ADDENDUM NUMBER 2
MLK Center Addition & Renovation
PB-BMG-0223
AUGUST 17, 2023

To all holders of Bid Documents; please be advised to the following:

1 Demolition Plan
AD1.0 Scale: 1/8" = 1'-0"

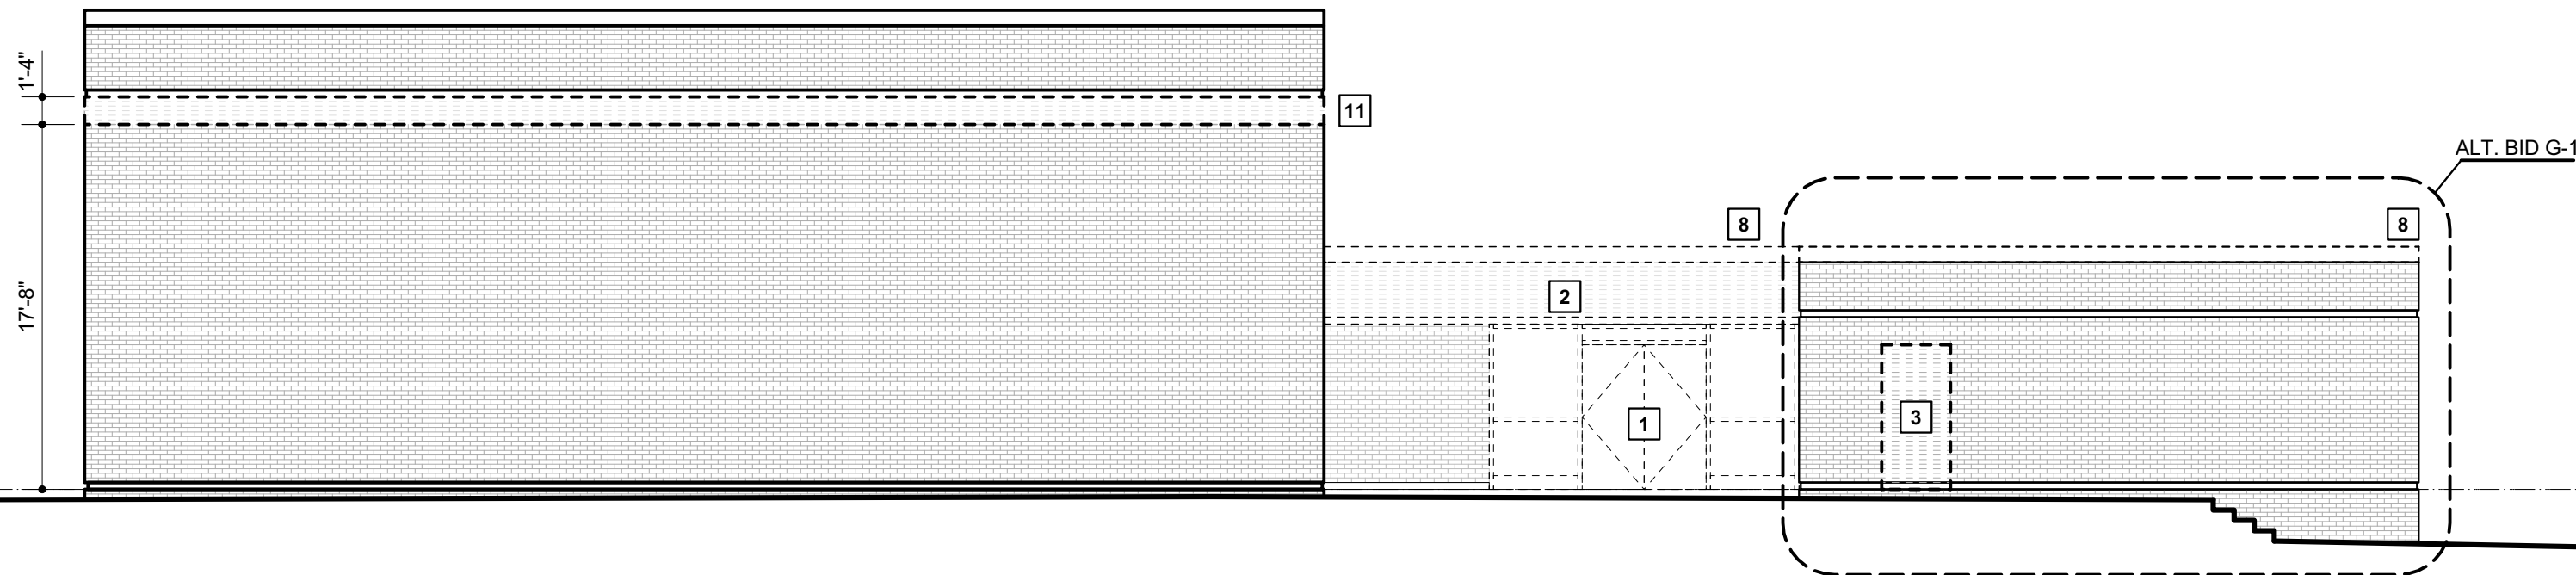
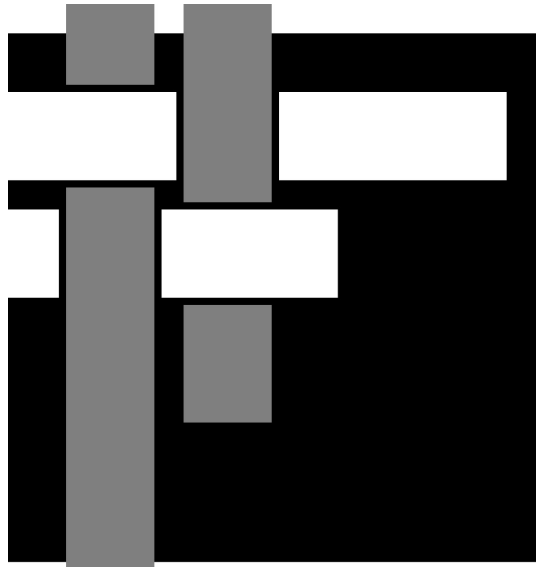
1. AD1.0, A1.1: Revisions to ceiling scope of work.
2. A1.2, A2.0, and A3.3: Downspout sizes are revised, overflow roof drain location and configuration revised.
3. A1.0, A4.1: Locations of water heater and mop receptor have been revised.
4. A6.0: Various revisions to Door Schedule and Finish Schedule.
5. A7.0: Detail 9/A7.0, list of doors with Type A signs revised.
6. P1.0 & P1.1: Overflow roof drain size, location, and configuration have been revised.
7. P4.0: In Storage Room 125, water heater WH-2 and mop receptor MR-1 have been relocated. Size of mop receptor MR-1 has been changed.
8. M0.1: Scheduled info for slot diffusers has been revised.
9. M1.1: CFMs for slot diffusers have been revised.
10. E0.2 & E1.3: Sheets have been revised to show work associated with access control system.

7. On sheet AD1.0, Demolition Key Note 9 does not appear on the plans or elevations. Please identify extent of work described by this key note.
 - a. **Demolition Key Note 9 is not used, please disregard.**

9 Signage Detail
A7.0 Scale: Half Actual Size

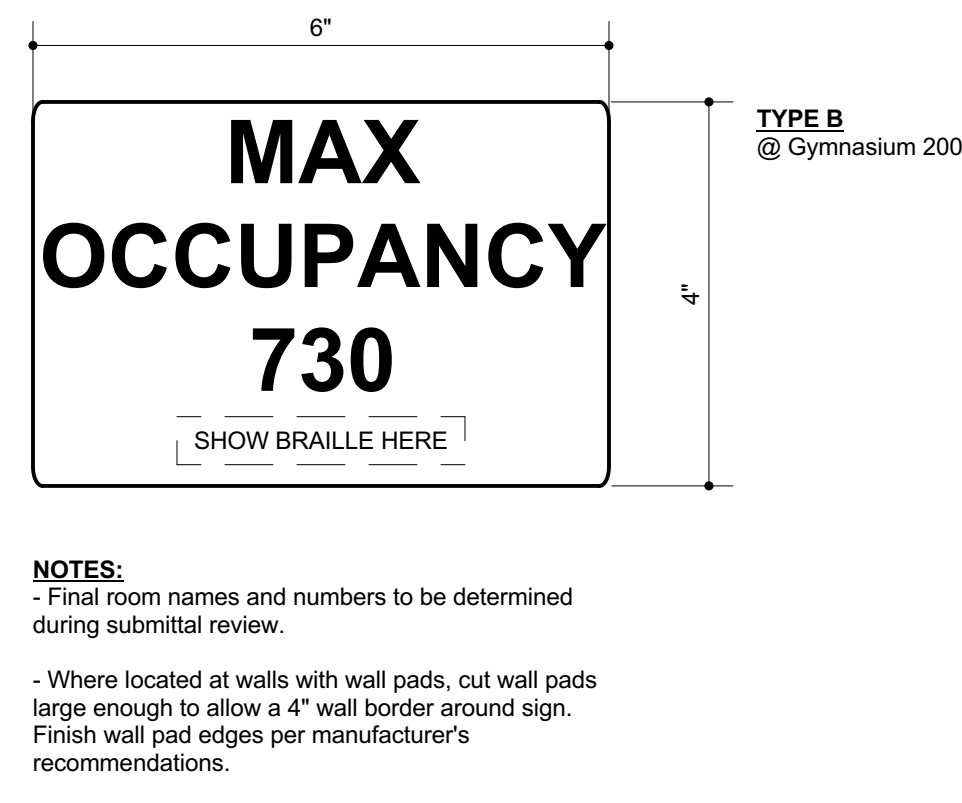
3. Please indicate which doors are to receive signage per section 10 1400, paragraph 2.02, B.
 - a. **Doors to receive signs with room numbers and names are indicated on sheet A7.0, detail 9.**

- b. **Restrooms and exits are clearly indicated on drawings.**
 - c. **Interior and Exterior Directional and Informational Signs: See sheet A7.0, detail 9.**
